Modification Recommended Service Note

P5001A Keysight Streamline USB Vector Network Analyzer

Serial Numbers: From MY58100696 to MY58100732

Potential lifted front panel overlay

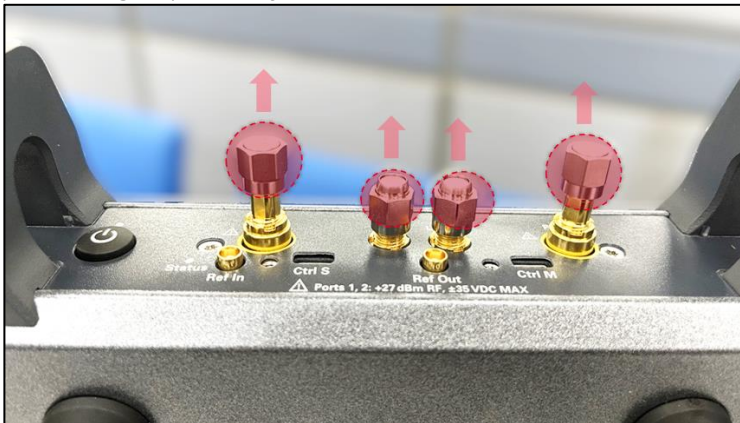
Keysight streamline series vector network analyzer (VNA) of serial number range identified in service note cover page might potentially exhibit the following lifted front panel overlay symptom.

Apart from cosmetic imperfections, the lifted front overlay could have led to non-fully attached *Ctrl S* micro-HDMI cable connector in multi-VNAs setup configuration.

-> Apply this service note only if end users' VNA is exhibiting the following symptom.

Procedure to replace the front panel overlay.

1. Remove the front handles. Detach the 50-ohm termination (LO-In, LO-Out, Port 1 & Port 2) or protecting caps if they are attached to the VNA.

2. Pry open the existing front panel overlay and remove it from front panel.
3. Clean the metal surface thoroughly and ensure it is free of adhesive residue.
4. Affix the new self-adhesive front panel overlay onto the metal surface.
5. Reinstall (reuse) the 50-ohm terminations or protecting caps accordingly.

6. Reinstall (reuse) the front handles.
